SUBJECT: **Addendum #3:** ITB-Lyon & Ivy Rd Storm Drainage & Utility Improvements

Project:	Lyon and Ivy Road Storm Drainage and Utility Improvements		Project No.:
Owner:	City of Fayetteville		
Engineer:	Timmons Group		
Offeror:

PLAN TYPE: DEMO	SHEET NUMBER C105
---------------------------	-----------------------------

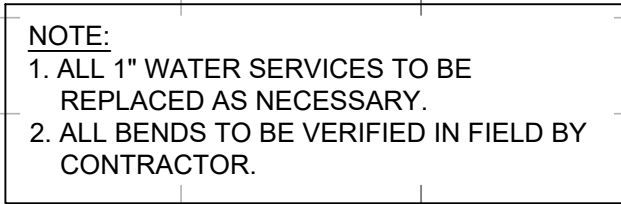
22. Are there any existing utilities that will need to be taken out of service to demo the pump house shown on sheet C-105? Please provide additional information on the requirements for demolition, disposal, backfilling, etc., of the pump house.

ANSWER: There are no known utilities providing active service to the decommissioned pump house structure. If any are encountered, contact the City prior to removing from service. The pump house structure is to be removed to grade and any buried foundation to be removed in the stormwater trench location. The existing underground vault previously

unknown to the project should be avoided as much as possible to avoid backfill requirements. Coordinate with the City/Engineer during construction if conflicts arise.
